APPLICATION NO.	FILING DATE	FIRST NAMED INVENTOR	ATTORNEY DOCKET NO.	CONFIRMATION NO.
10/537,812	06/07/2005	Markus Egerter	028987.55877US	5467
23911 7590 09/12/2007 CROWELL & MORING LLP INTELLECTUAL PROPERTY GROUP P.O. BOX 14300 WASHINGTON, DC 20044-4300			EXAMINER LUONG, VINH	
			ART UNIT 3682	PAPER NUMBER
			MAIL DATE 09/12/2007	DELIVERY MODE PAPER

Office Action Summary

- 1) ☒ Responsive to communication(s) filed on 05 July 2007.
- 2a) ☒ This action is **FINAL**. 2b) ☐ This action is non-final.
- 3) ☐ Since this application is in condition for allowance except for formal matters, prosecution as to the merits is closed in accordance with the practice under *Ex parte Quayle*, 1935 C.D. 11, 453 O.G. 213.

ATTACHMENT 1

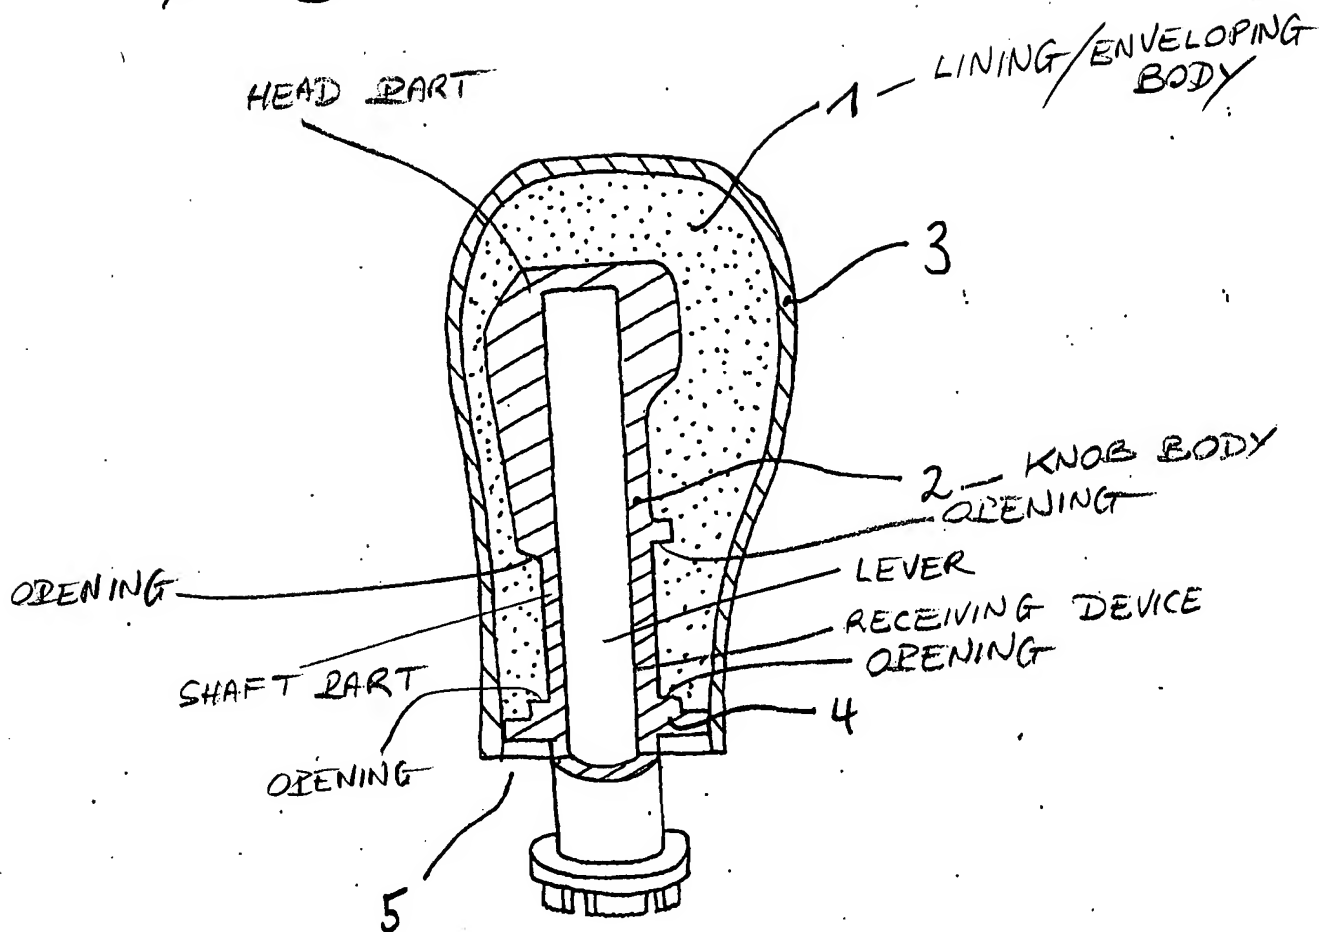
Regarding Claim 13, DE'566 teaches a knob or grip end (FIG. 1) for a control lever (see Attachment 1 hereinafter "Att. 1") of a motor vehicle, comprising:

a knob body 2 which has a receiving device (Att. 1) for the control lever, and
a lining 1 made of a flexible material, by which the knob can be fastened on the control lever (Att. 1),

wherein the knob body 2 has a shaft part (Att. 1) and a head part (Att. 1),
which the lining 1 is formed by an elastically constructed enveloping body 1 at least partially surrounding the shaft part (Att. 1), and

wherein openings (Att. 1) are provided in a lateral surface of the shaft part (Att. 1) and are penetrated by sections of the enveloping body 1. See *Derwent Abstract* attached.

Regarding Claim 15, the openings (Att. 1) extend in axial and circumferential directions of the shaft part (Att. 1).

ATTACHMENT 2

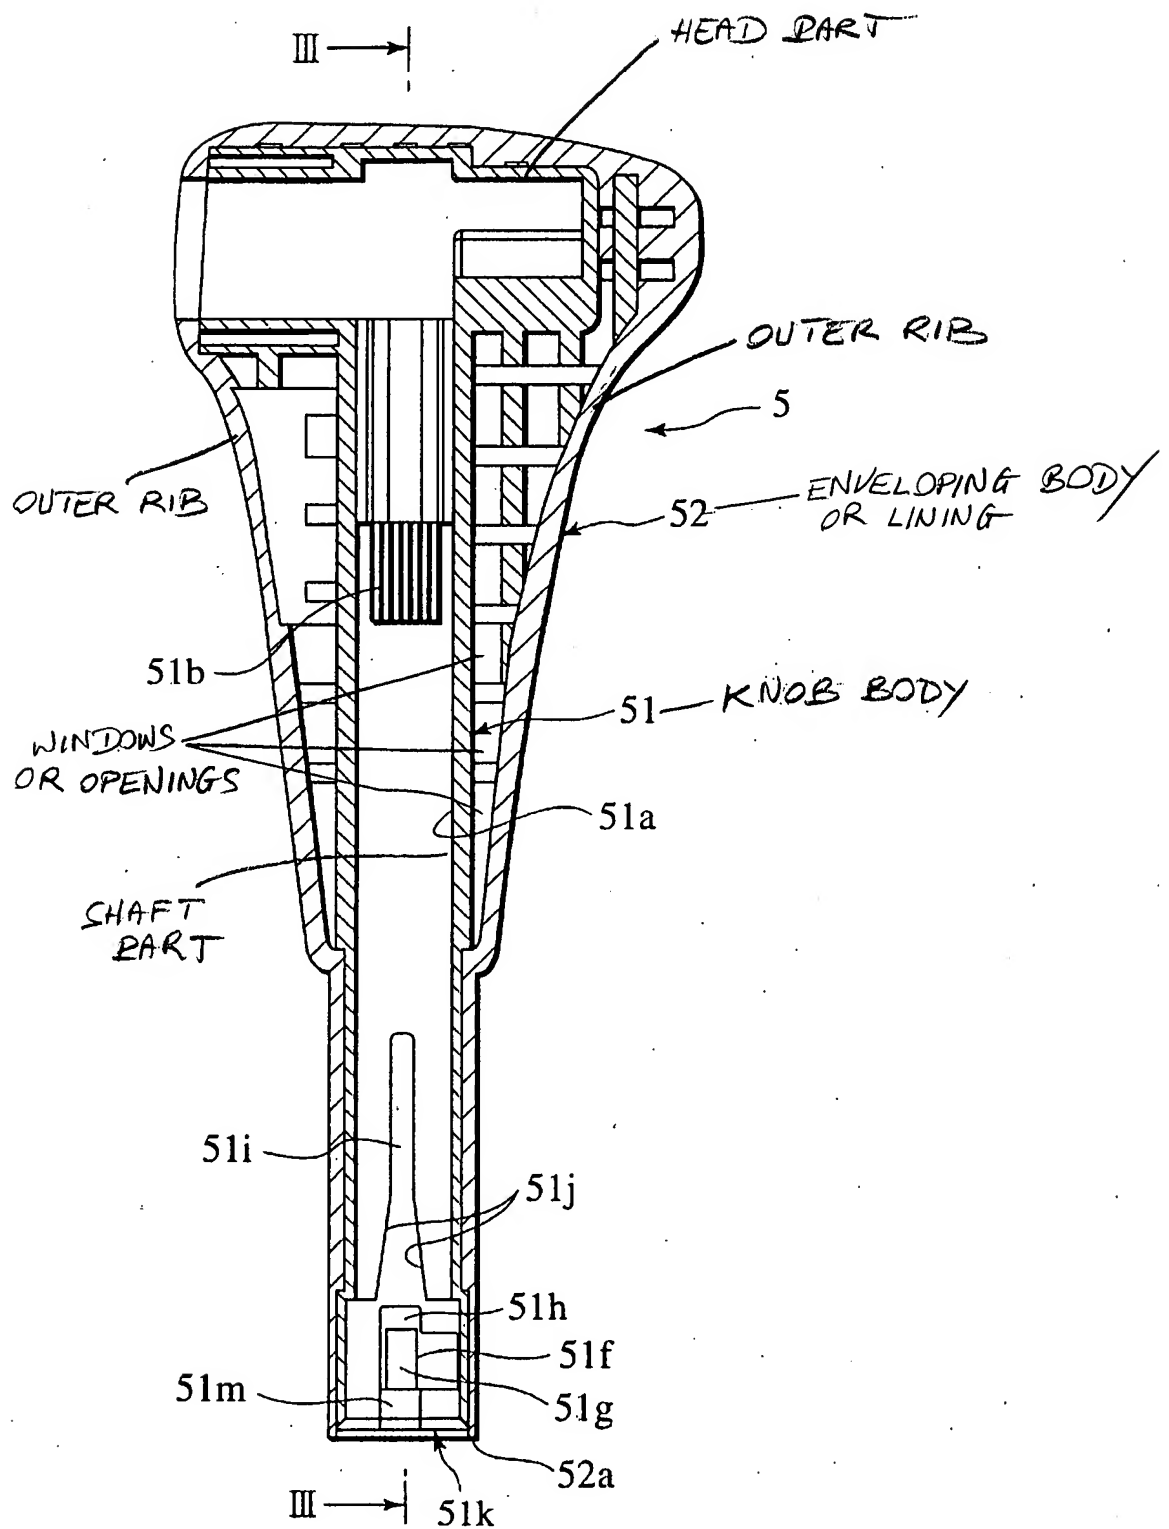
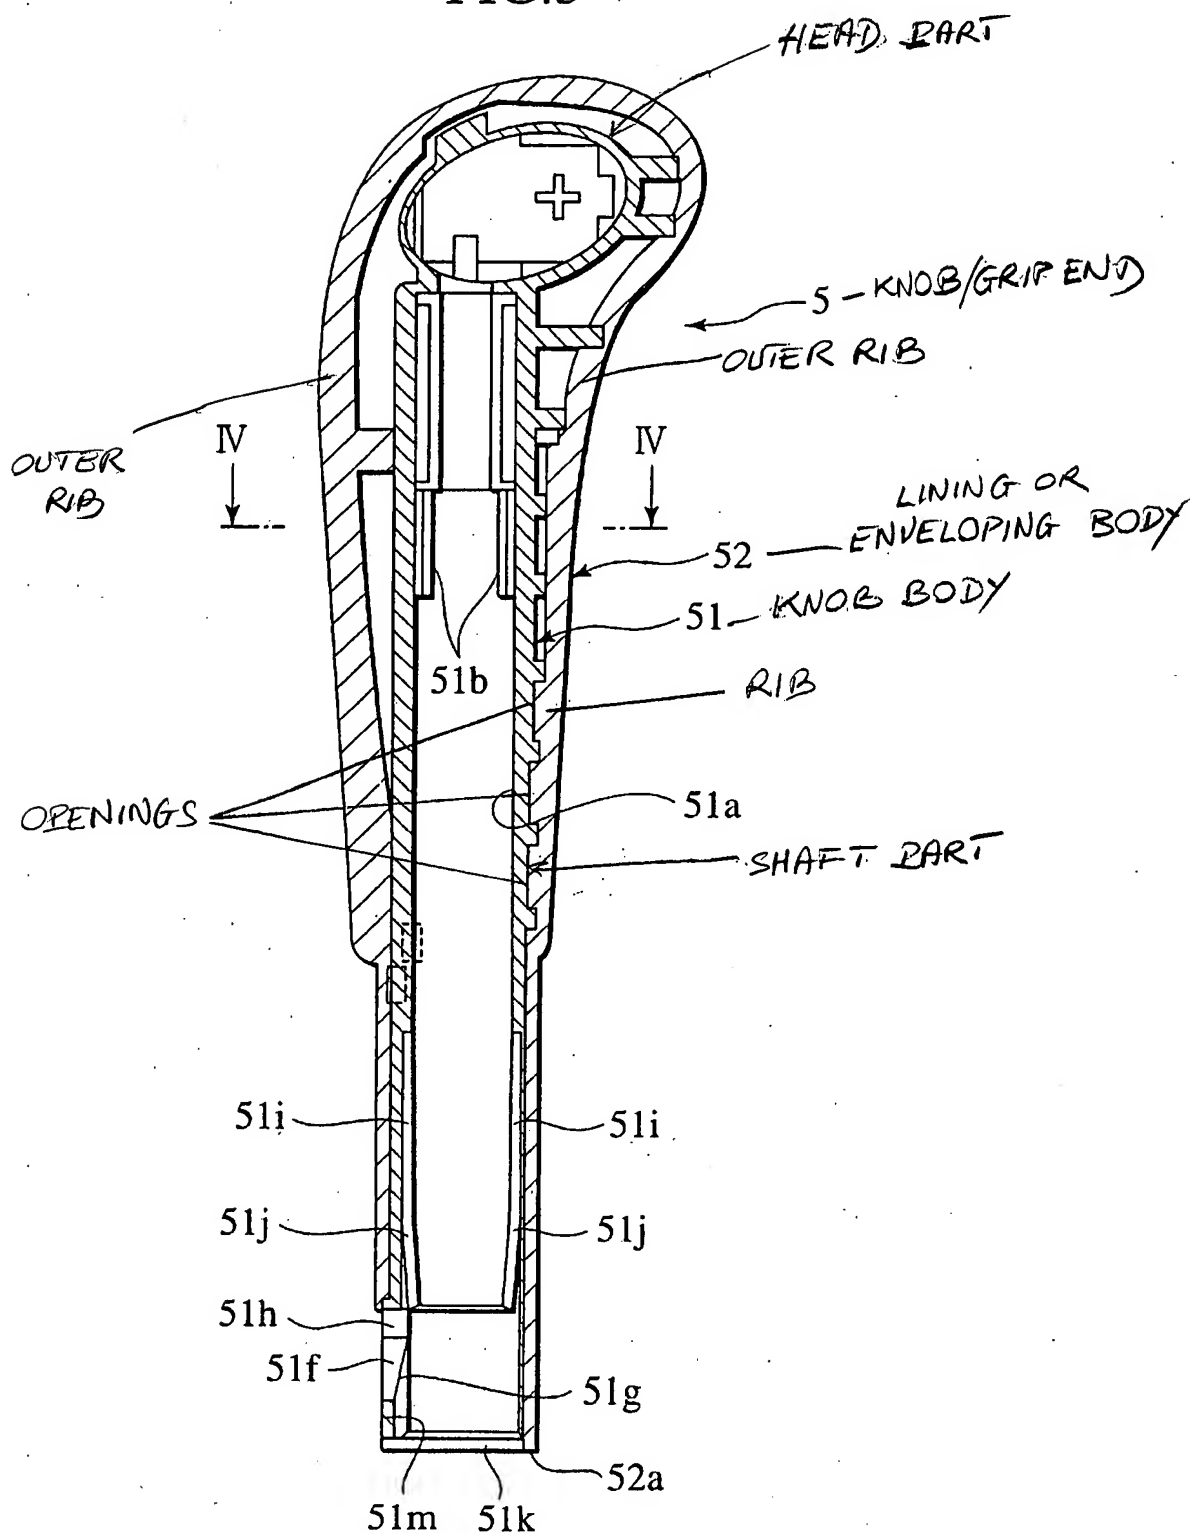
a knob body 51 which has a receiving device 51a (FIG. 3) for the control lever 2, and
a lining 52 made of a flexible material, by which the knob 5 can be fastened on the
control lever 2,

wherein the knob body 51 has a shaft part (at 51a in FIG. 2, see Attachment 2 hereinafter
“Att. 2”) and a head part (Att. 2),

which the lining 52 is formed by an elastically constructed enveloping body 52 (id. col. 4,
line 37+) at least partially surrounding the shaft part (Att. 2), and

wherein openings (FIGS. 2 and 3 in Att. 2) are provided in a lateral surface of the shaft
part (Att. 2) and are penetrated by sections of the enveloping body 52 as seen in FIG. 3.

Regarding Claim 15, the openings (FIGS. 2 and 3) extend in axial and circumferential
directions of the shaft part (Att. 2).

Regarding Claims 16 and 25, the openings (FIGS. 2 and 3) are constructed as windows,
and the sections of the enveloping body 52 engage in the windows (FIG. 3), and the sections of
the enveloping body 52 form ribs (Att. 2).

Regarding Claims 18 and 28, a detent device 21, 51b for axially fixing the knob 5 on the
control lever 2 is provided in the head part (Att. 2) of the knob body 51.

Regarding Claims 21 and 31, outer ribs (Att. 2) extending from the shaft part (Att. 2) to
the head part (Att. 2) are provided for anchoring the enveloping body 52.
